NORTH MACADAM DISTRICT STREET PLAN IMPLEMENTATION AMENDMENTS

Ordinance No. 171522

**Amendments to: the Zoning Code, Willamette
Greenway Plan, and the Design Guidelines for the
North Macadam District of the Central City Plan**

Map 510-7

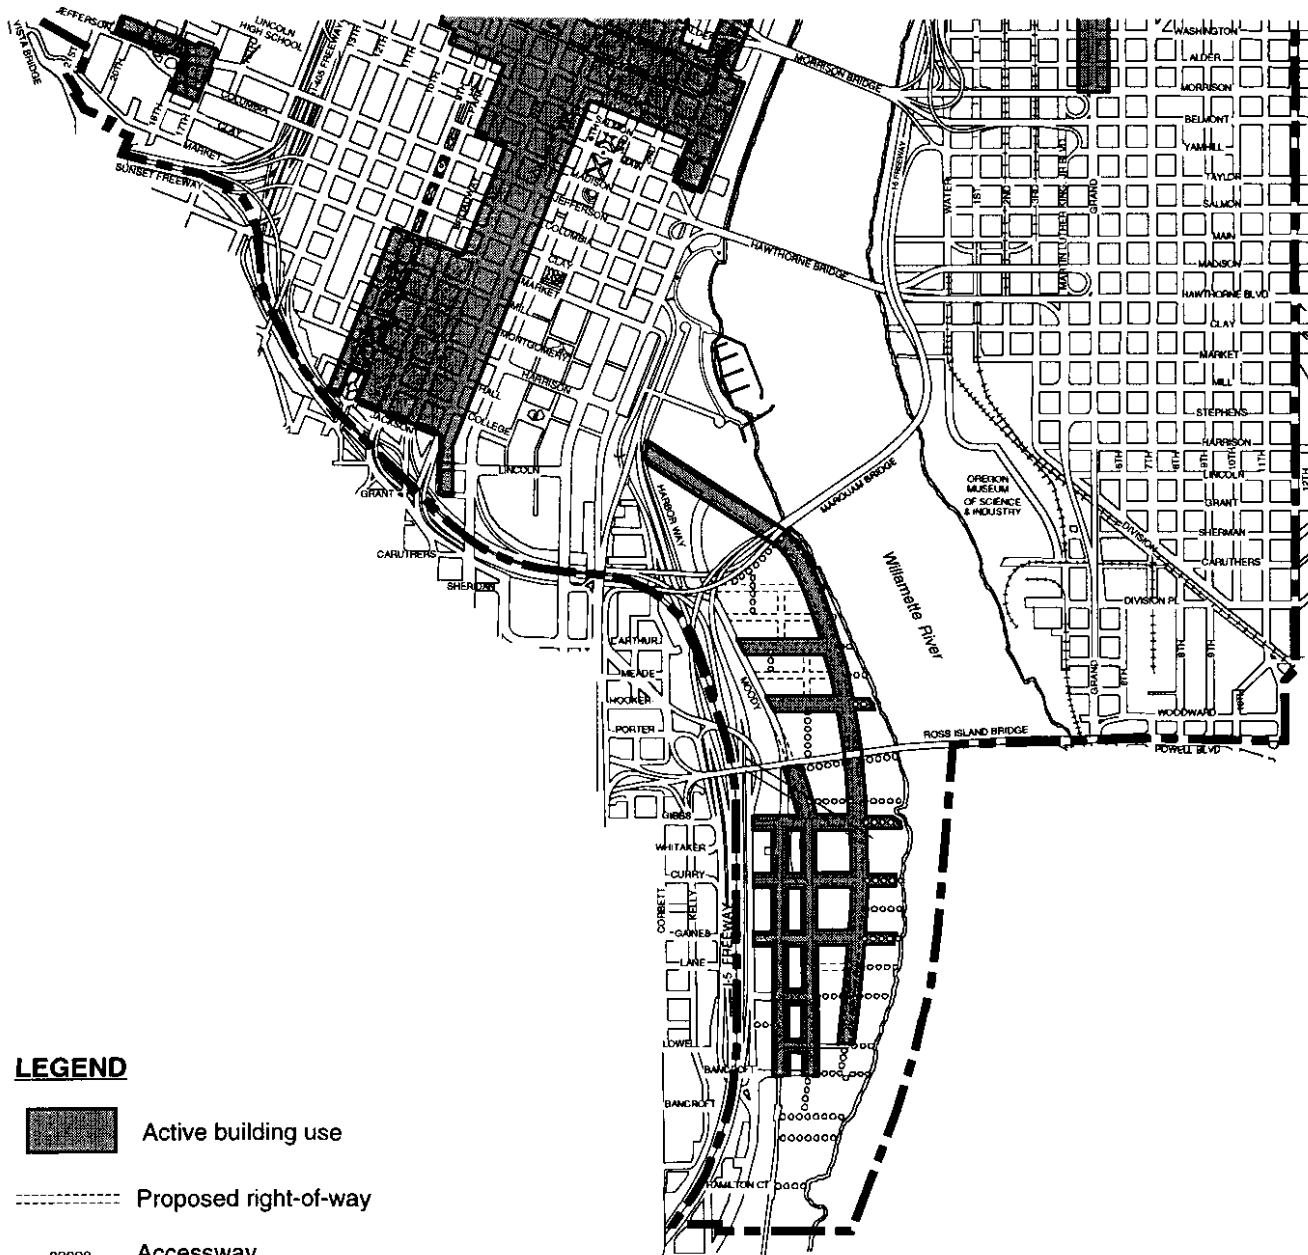
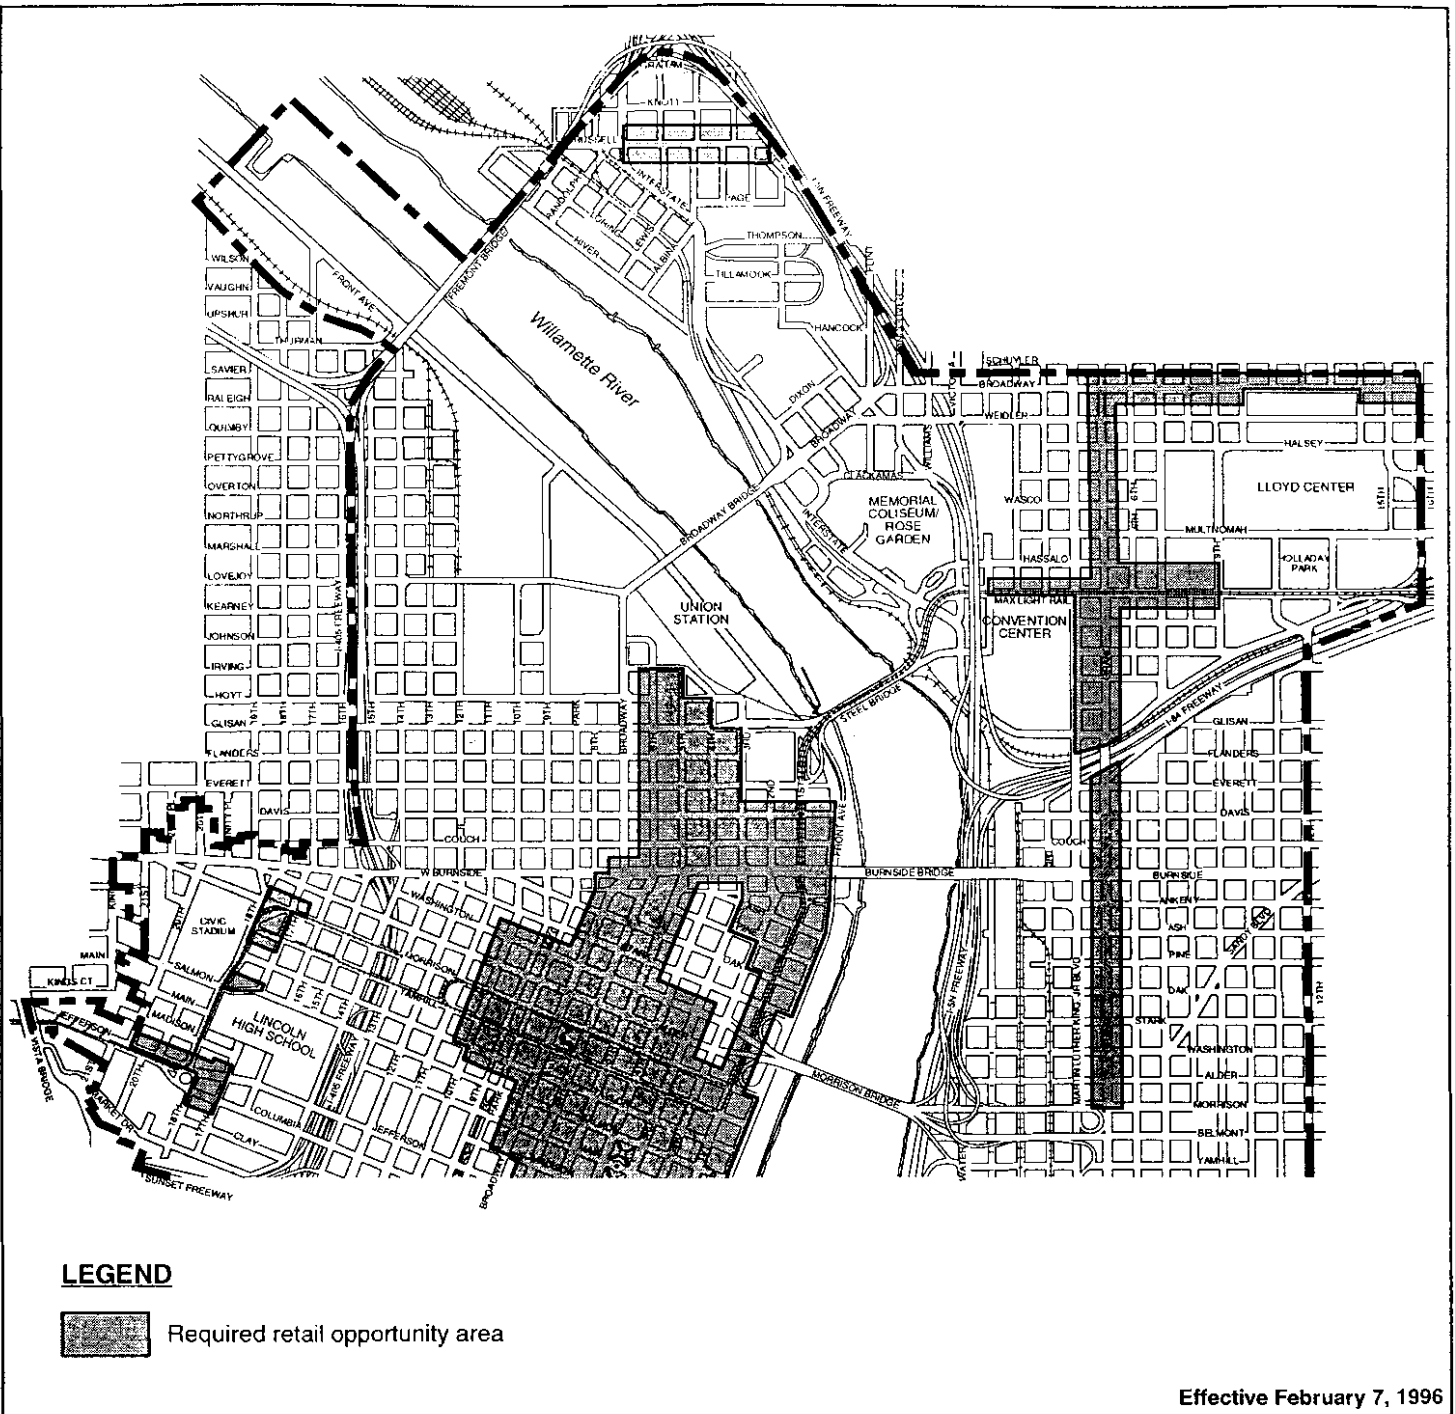
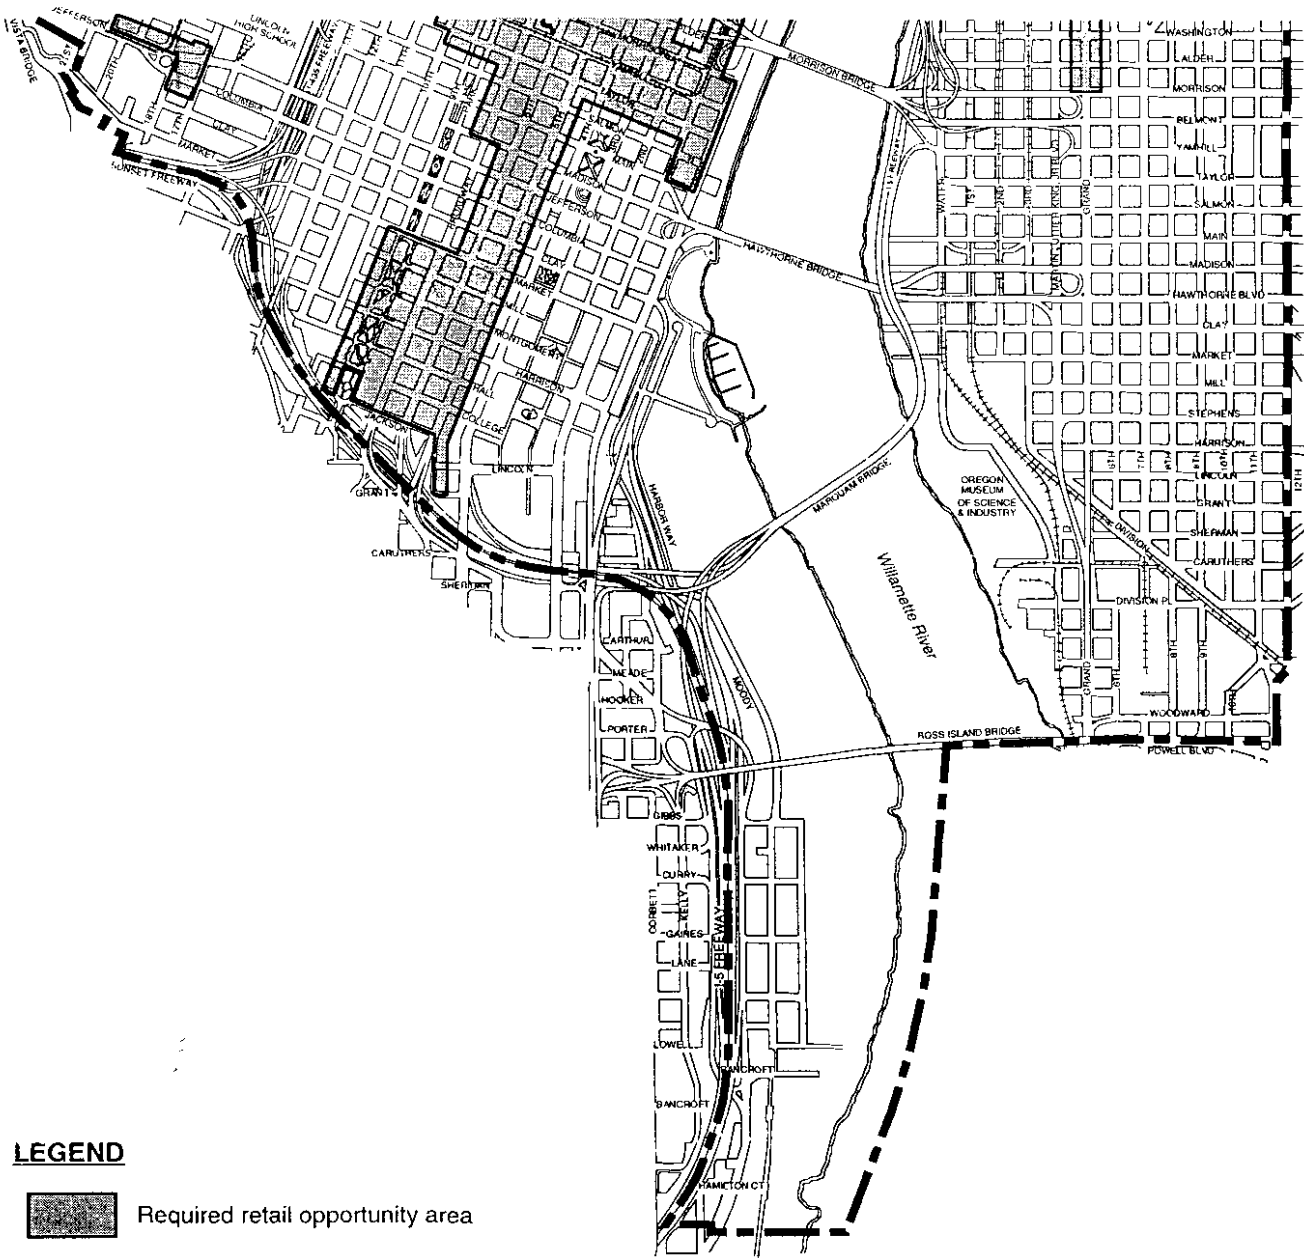
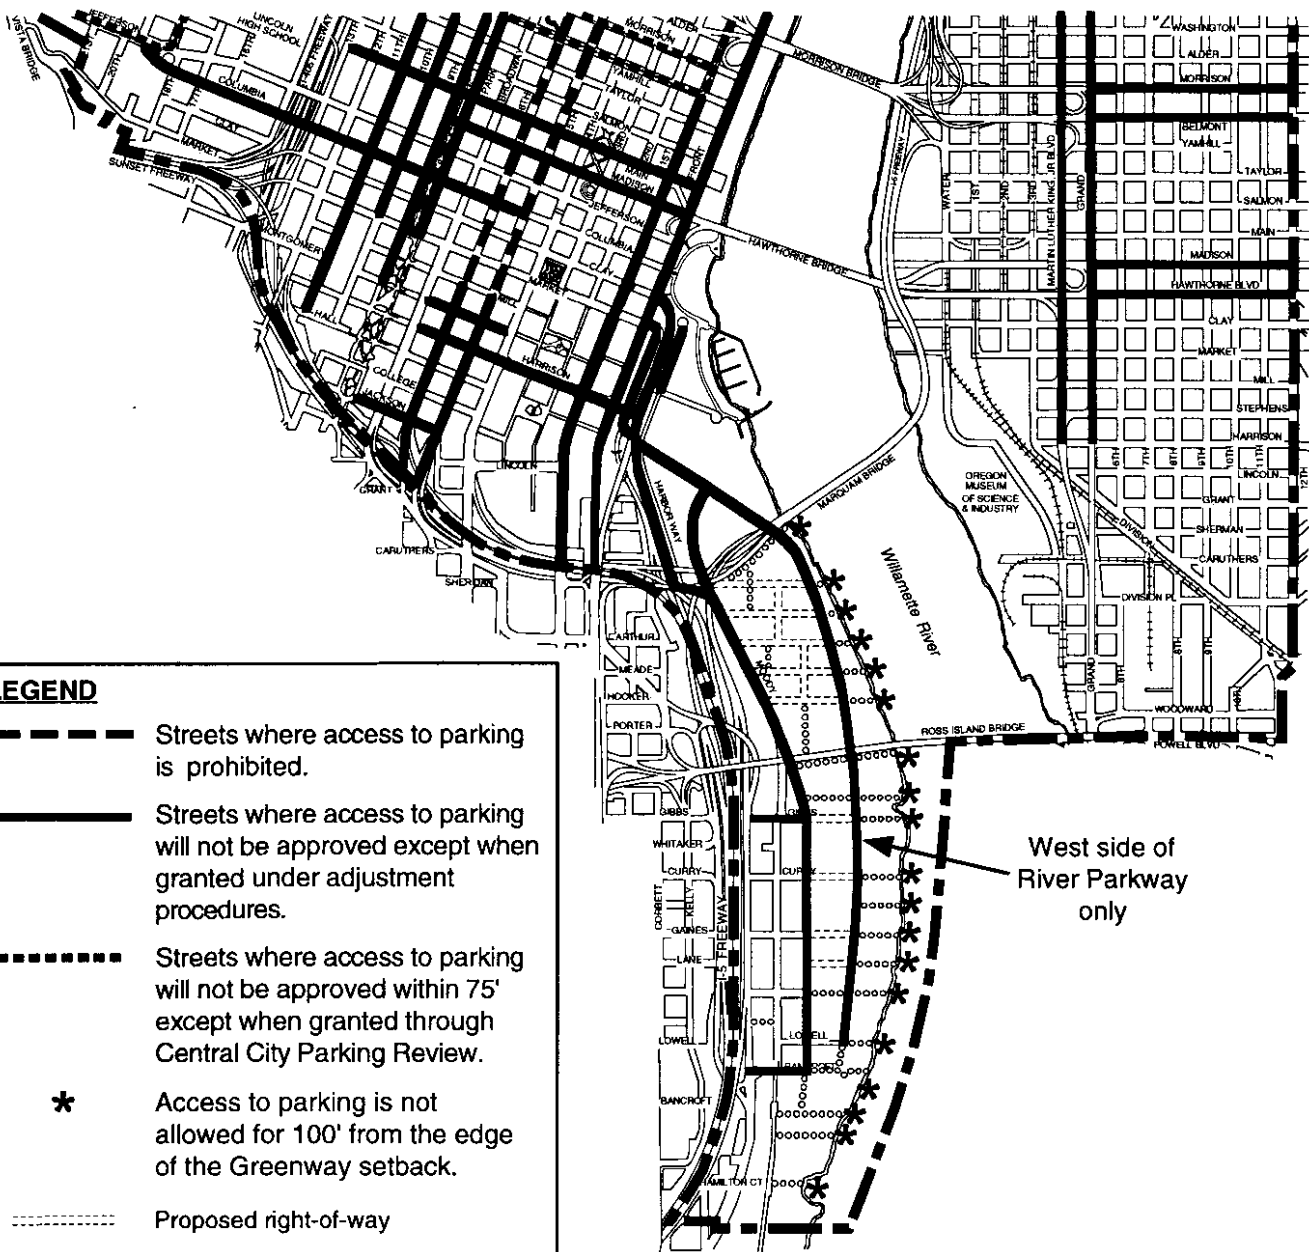
The City Council adopted three amendments, which: 1) Change the name and clarify the purpose of the existing Section 33.510.225 of the Zoning Code, replacing "Required Retail Opportunity Areas" with "Active Building Use Areas". 2) Apply the revised Section 33.510.225 to key north-south and east-west streets in the North Macadam District. These are the streets that are envisioned to accommodate enhanced pedestrian use and activity. See revised Map 510-7 (2 of 2) which follows. Please note that the above two revisions are a Central City district-wide amendment and Map 510-7 (1 of 2) is updated for title revision only. 3) Restrict parking in the area constructed to meet the active building use standard.

Generally, the identified corridors for Active Building Use Areas share similar characteristics as described in the North Macadam District Street Plan. They are multi-modal streets that will provide some form of transit: Light Rail, bus or street car. They are expected to have office, commercial, or retail uses along them, in addition to residential development on the eastern half of the district. They will be designed to reach an enhanced pedestrian environment that will be achieved through this standard, parking access restrictions, and right-of-way design features such as wide sidewalks.

**Map 510-9
Parking Access
Restricted Streets**

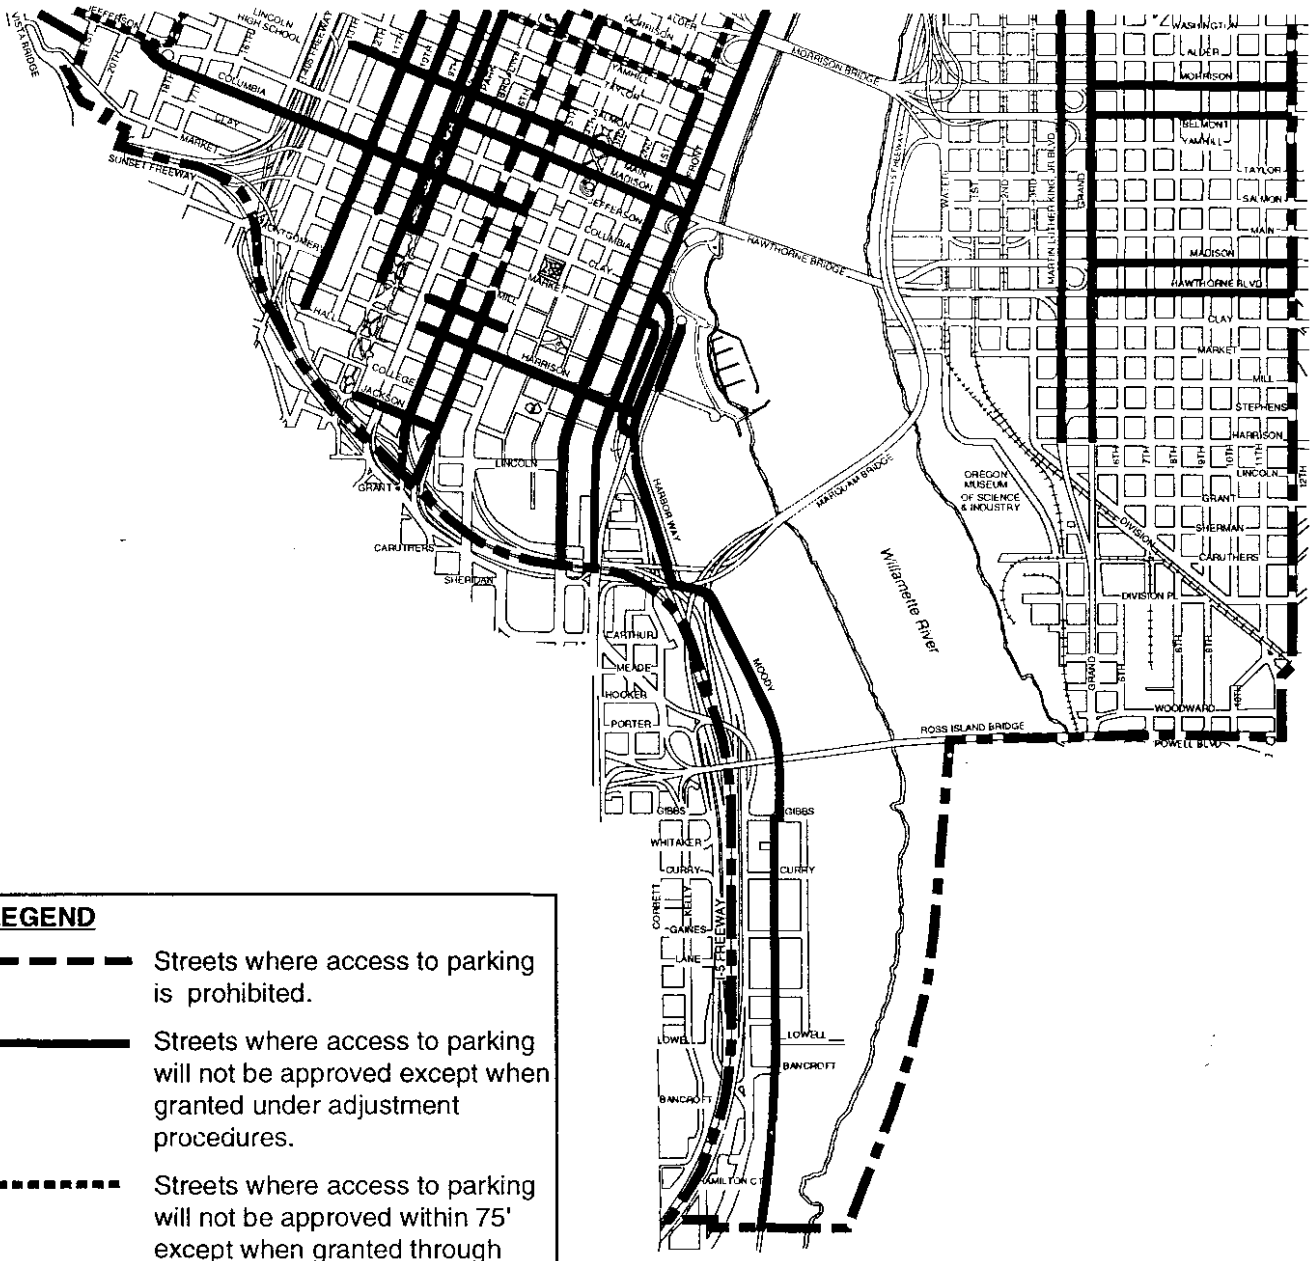
The City Council approved a parking lot access restriction through an amendment to the current Zoning Code Map 510-9. The revised map for the Parking Access Restricted Street indicates the accessways where the 100 foot restricted area would be applied to properties near the greenway. The specific restriction would be reviewed for compliance as part of the Design Review process for development approval.

As referred to in the previous section, there are certain streets identified in the North Macadam District Street Plan that will be enhanced for pedestrian-oriented street level activity. Since pedestrians and transit are important in the Central City, pedestrian safety and the reduction of multi-modal conflicts have been addressed in the street classification policy section by limiting parking lot accesses along key transportation corridors. The updated Map 510-9 indicates the north-south and east-west corridors where parking lot accesses would not be allowed. These streets are: SW Moody Avenue, SW River Parkway, SW Gibbs Street from SW Macadam to SW Bond, and SW Bancroft from SW Macadam to SW Bond.
